APPLICATION NO.	FILING DATE	FIRST NAMED INVENTOR	ATTORNEY DOCKET NO.	CONFIRMATION NO.
10/568,571	02/16/2006	Yutaka Akahori	9319A-001559/US/NP	6474
	7590 08/22/200 CKEY & PIERCE, P.L	EXAMINER		
P.O. BOX 828			COMLEY, ALEXANDER BRYANT	
BLOOMFIELD HILLS, MI 48303			ART UNIT	PAPER NUMBER
			3746	
			MAIL DATE	DELIVERY MODE
			08/22/2008	PAPER

Application No.	Applicant(s)			
	10/568,571	AKAHORI, YUTAKA			
Office Action Summary	Examiner	Art Unit			
	ALEXANDER B. COMLEY	3746			
The MAILING DATE of this communication app Period for Reply	ears on the cover sheet with the c	orrespondence address			
A SHORTENED STATUTORY PERIOD FOR REPLY WHICHEVER IS LONGER, FROM THE MAILING DA  - Extensions of time may be available under the provisions of 37 CFR 1.13 after SIX (6) MONTHS from the mailing date of this communication.  - If NO period for reply is specified above, the maximum statutory period w  - Failure to reply within the set or extended period for reply will, by statute, Any reply received by the Office later than three months after the mailing earned patent term adjustment. See 37 CFR 1.704(b).	ATE OF THIS COMMUNICATION 36(a). In no event, however, may a reply be tim vill apply and will ex

In regards to Independent **Claim 1**, and with particular reference to Figures 2 & 6 shown immediately above, Hyman et al. (5,217,355) discloses:

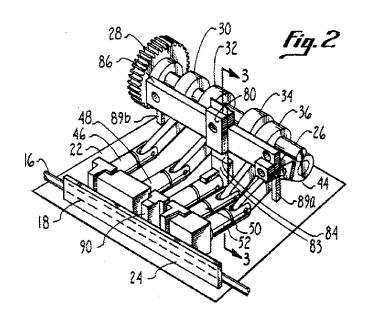
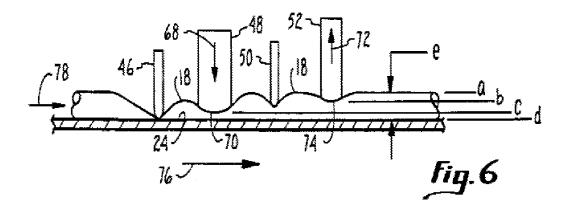
(1) A tube pump (10) for transferring a fluid, comprising: a tube (16) defining a flow path therein through which the fluid is transferred, the tube (16) being capable of being deformed elastically, the tube (16) having two opening/closing portions provided at two spaced portions of the tube (16) for opening and closing the flow path; and two opening/closing mechanisms (32, 36) which are provided so as to correspond to the two opening/closing portions respectively for closing the flow path at the two spaced portions of the tube (16) by folding the corresponding opening/closing portion of the tube (16) and opening the flow path by unfolding the fold of the opening/closing portion; wherein, when one of the two opening/closing portions is further folded after closing the flow path at the corresponding opening portion of the tube (16) by operating the corresponding opening/closing mechanism (48) in a state where the other opening/closing portion is folded, an internal pressure in the tube (16) between the two

As best shown in Figure 2 above, Hyman discloses a peristaltic pumping device that is utilized for precisely metering the flow of medical fluids to a patient. The tube has various opening/closing portions spaced along it's length, and the closing mechanisms are disposed therebetween. Hyman's pump utilizes different sized reciprocating fingers (48, 52) in order to maintain increased internal pressure within the tube. The fingers are reciprocated by a rotating camshaft with four individual cams corresponding to the four individual fingers. In particular, Hyman states "Each cam 30, 32, 34 and 36 contacts a corresponding linkage. Only linkage 44, which is associated with cam 36, is shown in FIG. 2. The cams 30, 32, 34 and 36 against the respective linkages and thereby drive pump fingers 46, 48, 50, and 52 respectively." (Column 4, Lines 55-62) As best seen in Figure 6 above, the pumping fingers (48, 52) are sized differently in order to pump different amounts of fluid through the tube, and consequently, provide increased pressure therein. In particular, Hyman states "With respect to the description of the invention herein, "large" and "small" describe pumping fingers which are constructed to move against tube portion 18 such that the amount of fluid displaced as "large" finger 48 moves downward against tube 18, is approximately two (2) times that displaced by an equal reciprocal downward motion of "small" finger 52. It is important to note that the reciprocal motion of fingers 48 and 52 is generally equal in range, but that in the fully extended position, the pumping fingers 48, 52 do not ever fully occlude the tubing."

(Column 5, Lines 58-68) Consequently, it is clear from this disclosure that the finger 48 provides an increased internal pressure within the tube due to its increased size.

5. In regards to dependent Claims 2-4 & 15, it is clear from Figures 2 and 6 that the mechanisms 48 and 52 are of different sizes in order to generate the increased internal pressure within the tube (See Column 5, Lines 58-68) Furthermore, Figure 2 best shows how the curved portions of the tube are folded through the pushing of the pumping fingers (48, 52) by their corresponding cam portions (32, 36). In regards to dependent Claims 5-6, the fingers (46, 48, 50, 52) and the cams (30, 32, 34, 36) form the cam mechanisms that each press against the tube and force fluid therethrough. The fingers (48, 52), as seen in Figure 6, are sized differently from one another in order to provide increased fluid flow while the cams (30, 32, 34, 36), as also seen in Figure 2, are semi-circular in shape. In regards to dependent Claims 7-10 & 18, the fingers/linkages of each cam mechanism are disposed on a base plate 22 and form a reciprocating frame that is driven by the cams (30, 32, 34, 36). As the cams are rotated, the frames are reciprocated toward and away from the tubing by the action of the rise and dwell of the cams, as well as the by resilient action of the tube itself. The cams' dwell portions each serve to help bias the frame away from the tubing and release the fold applied thereto. In such a linkage, the fingers act as the direct connection between the tube closing portions and the frame. Regarding dependent Claims 11-13 & 19-20, Figures 2 best shows that the pump of Hyman utilizes a platen (i.e. fixing jig) to position the tube upon the base. In particular, Hyman states "The components of

peristaltic pump apparatus 10 can be best appreciated with reference to FIG. 2, where it will be seen that peristaltic pump apparatus 10 includes a base 22 which has a generally flat platen 24 Platen 24 provides a surface against which portion 18 (shown in phantom in FIG. 2) of tube 16 may be occluded." (Column 4, Lines 49-54) Obviously, adjustment of this platen, or jig, directly affects the amount of compression applied by the adjacent cam mechanisms. Furthermore, Hyman discloses that the pinching fingers (46, 50) alternately fully occlude/fully open the flow tube. In particular, Hyman states "As can be appreciated from the disclosure above, and again referring to finger 46 as an example, the reciprocating motion of finger 46 causes it to alternately press against and withdraw from tube portion 18. Finger 46 thereby alternately occludes and opens tube portion 18." (Column 5, Lines 31-36) Consequently, the flow path is always closed by one of the two pinching fingers fully occluding the tube. In regards to dependent Claims 16-17, Applicant's "stepped cam" is taught by Hyman's cam/linkage/finger mechanism (See Figure 2). In particular, Hyman's mechanism comprises four separate semicircular cams (i.e. cam portions) that actuate linkages (i.e. arms) in order to reciprocate differently sized fingers (i.e. actuators). The outer peripheral surfaces of each cam rotates to convert rotational motion into linear reciprocating motion in order to bring each of the linkages (i.e. arms) and fingers (i.e. actuators) into physical contact with the opening/closing portions of the tube. Hyman states "Mounted on base 22 is a rotatable shaft 26, which is driven by a motor (not shown) that engages with gear 28. Shaft 26 also includes cams 30, 32, 34 and, 36. Each cam 30, 32, 34 and 36 contacts a corresponding linkage. Only linkage 44, which is associated with cam 36, is shown in

FIG. 2. The cams 30, 32, 34 and 36 against the respective linkages and thereby drive pump fingers 46, 48, 50, and 52, respectively." (Column 4, Lines 55-62) Hence, the different sized, co-rotating fingers of Hyman's stepped cam mechanism provide tube folding in a "stepwise manner" in order to produce efficient fluid flow through the tube.
